Receiver Interference Tolerance (83D.3.2.2)

Ryan Latchman, Mindspeed

IEEE 802.3bm

Figure 83D-12—Interference tolerance test setup

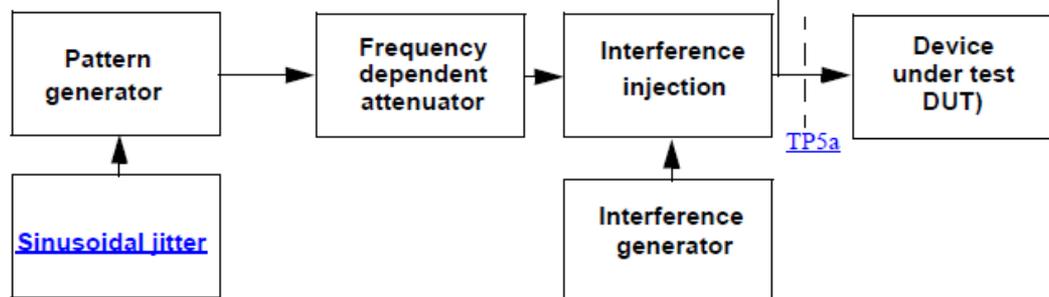
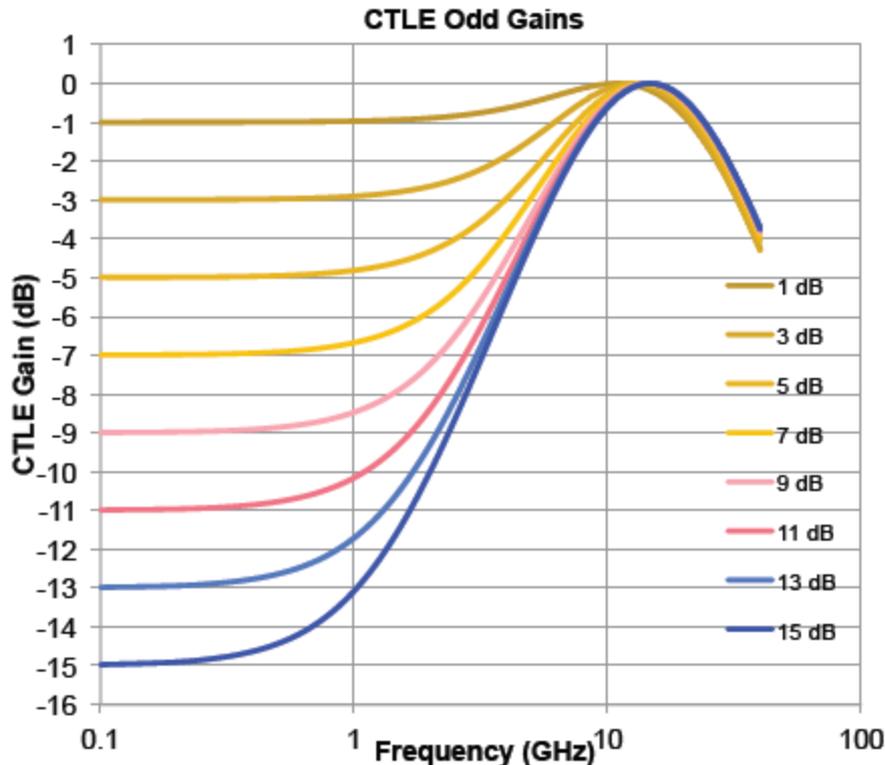
Change figure 83D-12 “frequency dependent attenuator” to “ISI channel”, change “Channel insertion loss...” to “ISI channel insertion loss”

Change figure 83D-12 to add random jitter box as an input to the pattern generator

Figure 83D-11—Selectable continuous time linear equalizer (CTLE) characteristic

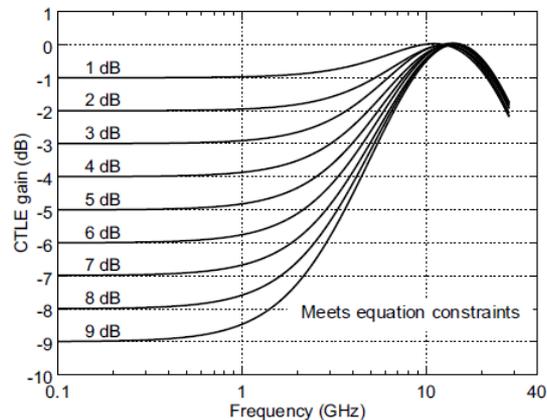
Reference receiver CTLE update

Gain (dB)	G (Linear)	Z (GHz)	P1 (GHz)	P2 (GHz)
1	0.89125	8.3640e9	1.86e10	1.41e10
2	0.79433	7.0990e9	1.86e10	1.41e10
3	0.70795	5.6760e9	1.56e10	1.41e10
4	0.63096	4.9601e9	1.56e10	1.41e10
5	0.56234	4.3580e9	1.56e10	1.41e10
6	0.50119	3.8440e9	1.56e10	1.41e10
7	0.44668	3.3990e9	1.56e10	1.41e10
8	0.39811	3.0120e9	1.56e10	1.41e10
9	0.35481	2.6720e9	1.56e10	1.41e10
10	0.31623	2.3728e9	1.56e10	1.41e10
11	0.28184	2.1090e9	1.56e10	1.41e10
12	0.25119	1.8755e9	1.56e10	1.41e10
13	0.22387	1.6690e9	1.56e10	1.41e10
14	0.19953	1.4853e9	1.56e10	1.41e10
15	0.17783	1.3225e9	1.56e10	1.41e10
